1	UNITED STATES OF AMERICA
2	NUCLEAR PEGULATORY COMMISSION
3	
4	CONFERENCE
5	NPC STAFF - GPU NUCLEAR TMI
6	
7	
8	7735 Old Georgetown Poad
9	Room 6507
	Pethesda, Maryland
10	Tuesdav, 5 May 1984
11	
12	The above-entitled meeting was convened at 10:00 a.m.
13	
14	
15	
16	
17	
18	
19	
20	
21	
22	
23	
24	
25

The subject today is in-service testing of pumps

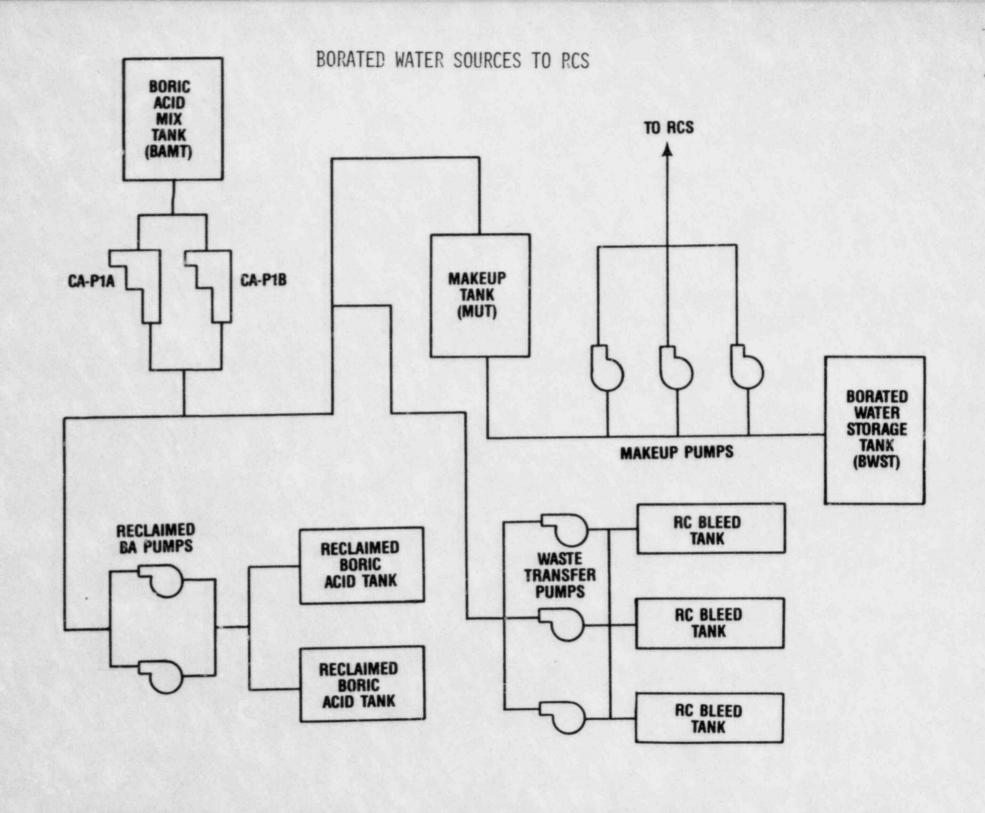
1 MR. PAGE: I thought the discussion here was 2 one of four pumps? 3 MR. ABRAMOVICI: One of four for tech spec. One 4 of seven available, from a plant standpoint, from an operating 5 standpoint. Let me put this slide back up again. (Slide.) 7 MR. PAGE: Even if the argument were one of seven, 8 how could you say that one of seven is operable, if they're 9 not all tested? After a long period of time, how do you 10 know if the component is operable indeed? 11 MR. ABRAMOVICI: Those pumps do get in operational 12 service. They're being used in the service to make up water. 13 MR. PAGE: Why not say you have six of them on 14 the bare bones edge of falling apart? They'd be running. 15 Would they make an accident run? 16 MR. ABRAMOVICI: They're not required in an 17 accident mitigation scenario. 18 MR. PAGE: None of them are, but they're required 19 to be operable. At least one of these four. I don't agree 20 with the argument, personally. 21 " SHIPMAN: What is different about, I believe, 22 what you of Mr. Thompson was the tech spec change requested is now under new for operability definition. We have an 24 operability a dition in our tech spec now. We've been

operational readiness, you're into the IST Program. So I guess the question we're asking you is do you need these pumps to respond to any of your postulated accidents?

MR. CHERNY: The answer to those two questions apparently are different. No, they don't need them for accident mitigation. Yes, they have to be in the tech specs. And that doesn't make sense to me.

MR. PAGE: I think we understand the one out of seven argument, which I don't think is really included in your tech specs because it should say one out of seven, if that's the situation. But it doesn't even tell you how you show one. No one really discusses what do you do if you don't do IST. There's something that you said -- I forgot your name back there, but there's some sort of testing operational running, or whatever.

MR. BOSNAK: I think that's the way -- we're going to recommend we resolve the inconsistencies and change the tech specs. Therefore, there would be a basis for removing this from the IST program.

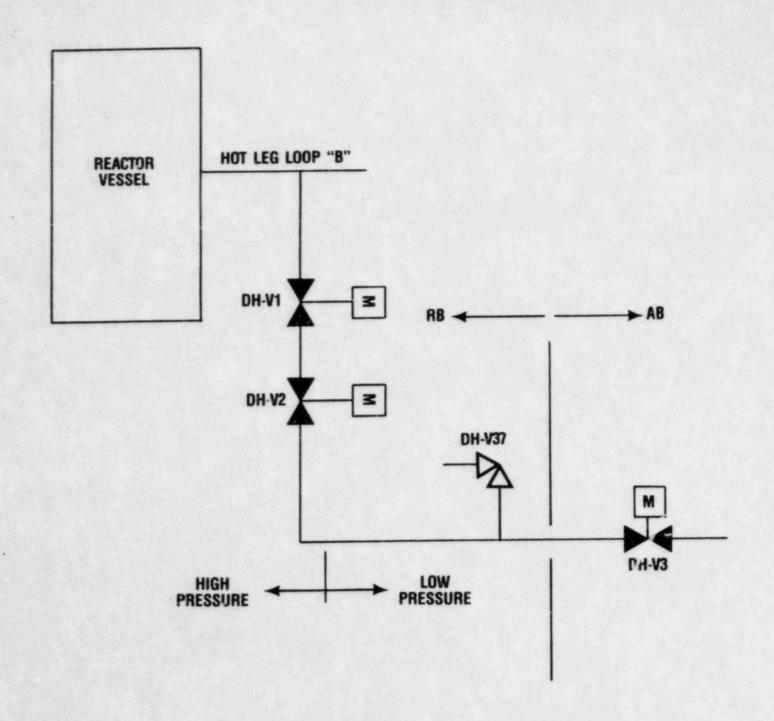
MR. ABRAMOVICI: The next two valves in question are DH-Vl and DH-V2. The drop line in the D hot leg loop suction to the decay heat system during normal operations, during decay heat normal operations. Then the line, this line, also has a leak valve, DH-V37 and DH-V3. It's the outside containment isolation.

MR. COLITZ: The only way you test those two is to make plant modifications. And even to do DH-V2 you'd have to tie in there with a hydro-pump in addition to that.

MR. CHERNY: Let me ask, just a clarification-type question. If you are below 400 psi, this is the interlock set point, can you individually open and close Vl and V2, or do they only open and close as a pair?

DH-V14A/B

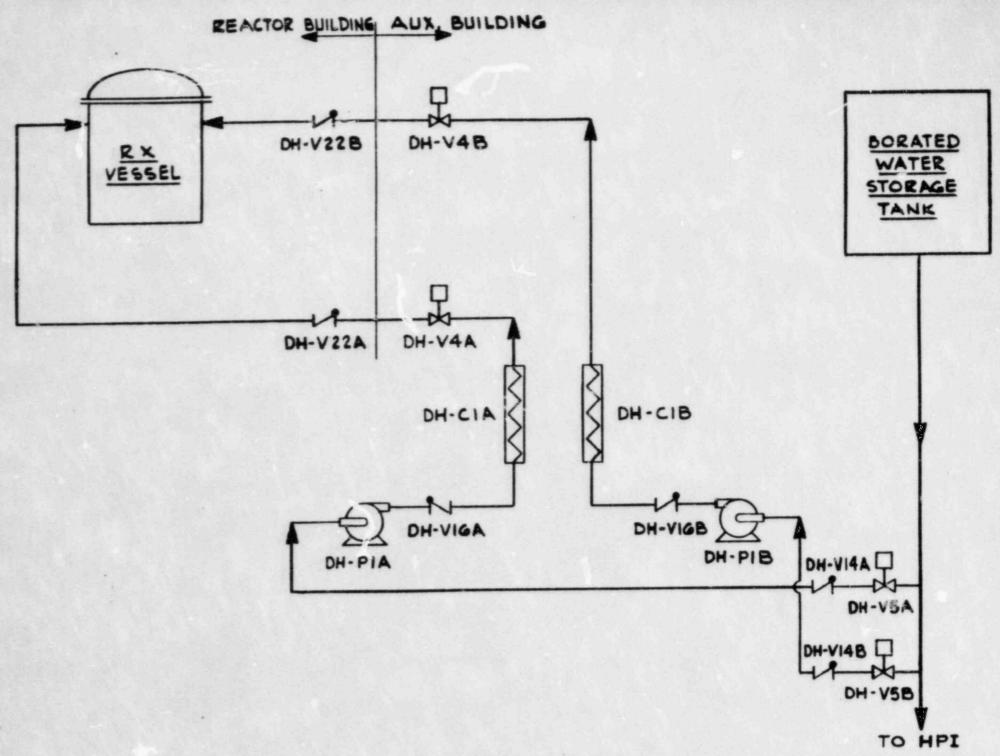
The problem of taking the actual equation for the percent open, they consider that proprietary. I have asked them -- we will ask them for a letter saying that for 3000 gpm the valve is 71 percent or 73 percent open. If that is adequate, we will provide that.

delta p, you have to assume a position of the disc. Otherwise your flow coefficient, C_{V} value will change. In other words, the C_{V} is a fixed value for the valve in one position, in the full open position. The only way you can know it's full open is to know the delta p of the valve and so much line is associated between the pressure gauges and the flow rate.

MR. PAGE: For some given conditions, that I guess you guys can provide, under tests, the valve will be X percent open or will provide X percent of this flow rate.

MS-V9A/B

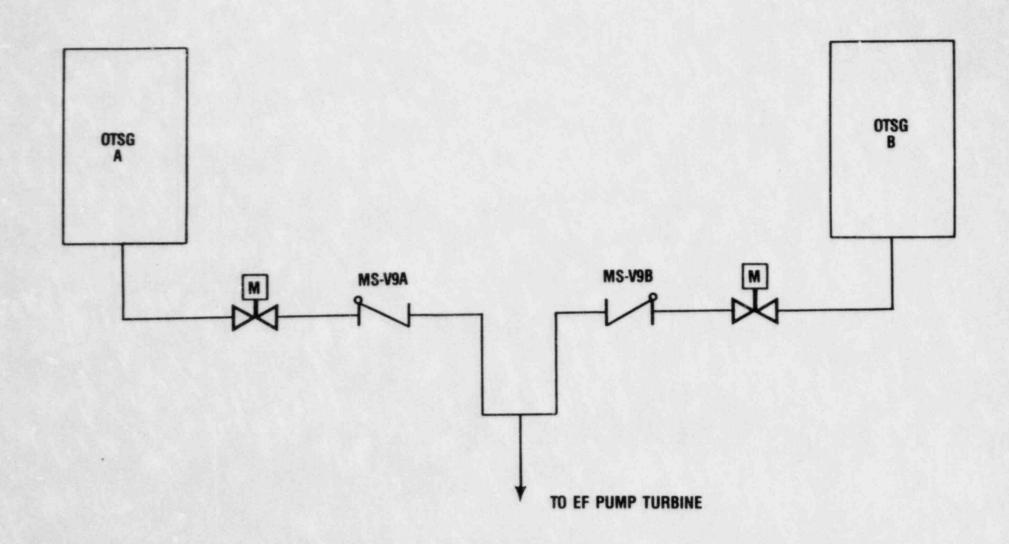
MR. PAGE: Is there some restriction on the pump as to what is the minimum required steam to get it to speed? Surely that should be right in the specifications. Can you provide us just that part then? Because that way I'll know how much steam flow is the minimum required to get to speed.

MR. PAGE: Your philosophy was saying, part stroke is adequate to show that the component will do its whole job. That's exactly what you're saying, and I totally disagree.

MR. PAGE: I'm saying you should set up something that verifies at least there's no change from your reference condition.

BS-V52A/B

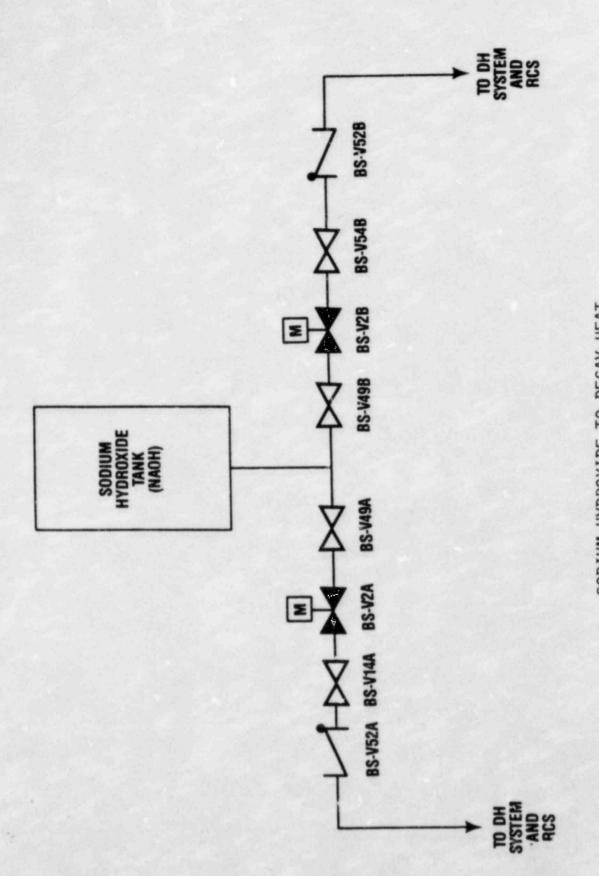
auxiliary building, with the flange. Those valves, I think, 1 are lopped closed. 3 MR. COLITZ: All three valves you're looking at 4 there are lopped closed. 5 MR. PAGE: So, basically, the system is just totally a piece of pipe sitting there. There's absolutely no requirement on the system anymore. 8 MR. ABRAMOVICI: That's correct. 9 (Slide.) 10 Again; just to make it complete, it's deleted from the building spray; common line from the tank has been cut 11 12 and capped. 13 (Slide.) 14 Now, we can go to BS-V52. This is the BS -- 52A -- came out as 44A. 15 16 The purpose of this line, as far as the building spray system, is to provide sodium hydroxide to the LPI system 17 and the building spray for fission control and post-accident 18 19 cooling. 20 During normal operation this line is isolated 21 only during accident. 22 BS-V2s are open and would allow sodium hydroxide to the LPI. 24 MR. PAGE: The point of discussion is the full 25 stroke on the 52 valves?

1 MR. ABRAMOVICI: Yes. 2 (Slide.) 3 We feel, by testing these valves, we would 4 introduce or increase the potential for sodium intrusion into 5 the reactor coolant and increase the sodium 24 activity 6 levels. 7 Secondly, we inspected those valves this year, 8 and they appeared in as-new condition. MR. COLITZ: Inspected both valves? 10 MR. ABRAMOVICI: Both valves. 11 Any questions? 12 MR. PAGE: You said you wanted a part stroke each 13 refueling; is that what you said originally? Maybe you 14 changed that. 15 MR. ABRAMOVICI: I think in our submittal we said 16 part stroke because of the sodium intrusion potential and 17 so on, the difficulty of flushing out the lines. 18 MR. PAGE: So, you're withdrawing that proposal 19 for part stroke? 20 MR. ABRAMOVICI: Yes. 21 MR. CHERNY: The proposal on that is what? Just 22 to disassemble every 10 years; is that what you're saying? 23 MR. ABRAMOVICI: That what we supplied in the 24 original. 25 MR. PAGE: Would you be amenable to all the roles

MU-V94, 95, 86A/B, 220

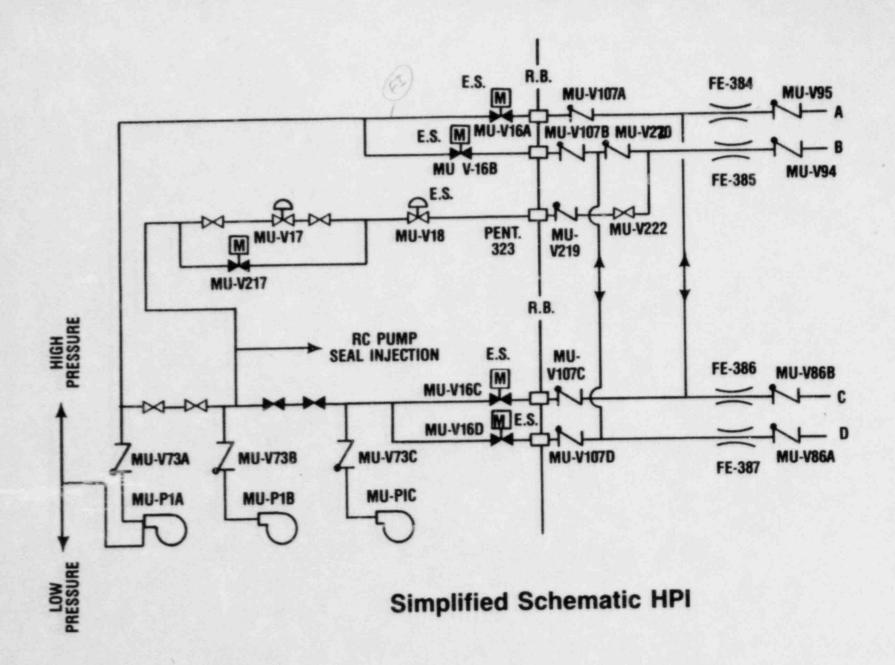
Same slide back up again. This deals with stroke testing both MU-V95, 94, 86B and 86A and we have added to the list MU-V220 because at time of submittal I guess originally HPI cross connects were not in.

MR. PAGE: 385, 386, 384. What my question was on there, do you have any details of what your startup test plans are based on what your readings are?

EMERGENCY FEEDWATER BACKUP SUPPLY FROM EMERGENCY RIVER WATER SYSTEM

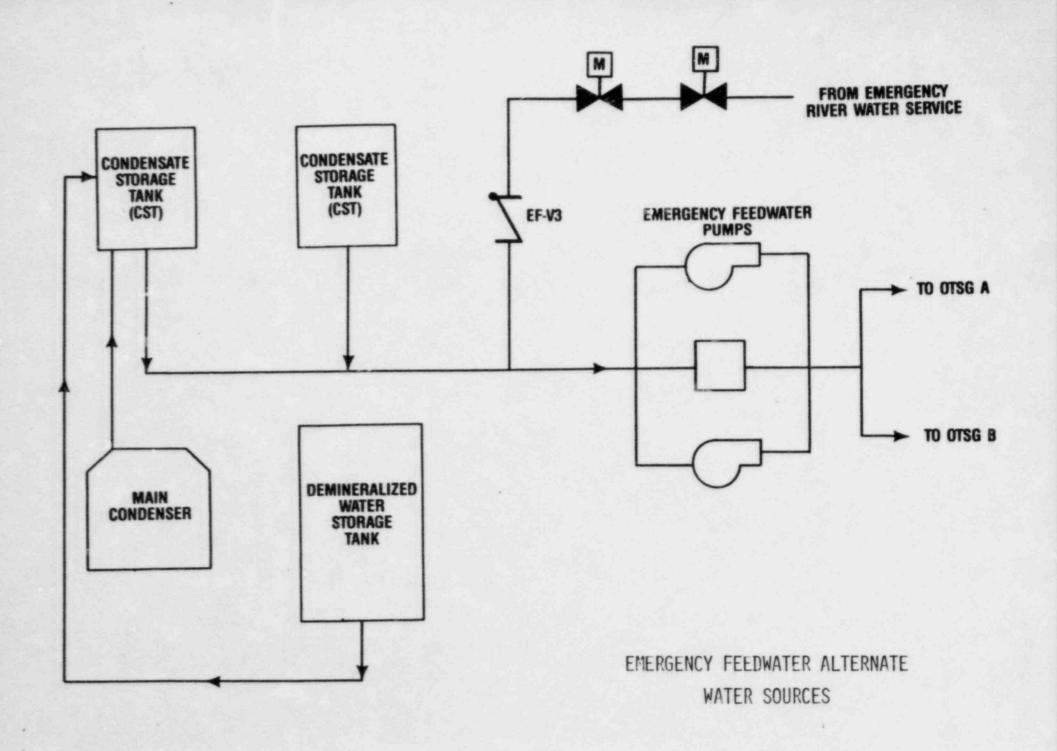
MR. PAGE: You always have higher pressure in the system than you do out here, attached to the end of this pipe, coming from the river. Is that correct?

MR. THOMPSON: So the question appears to be one, can you essentially remove that check valve by taking out the internals and if that's not a viable option, what can be done to do an inservice testing program on it?

MR. PAGE: Can you include this in the disassembly report, if that be the answer, as opposed to gutting the valve?
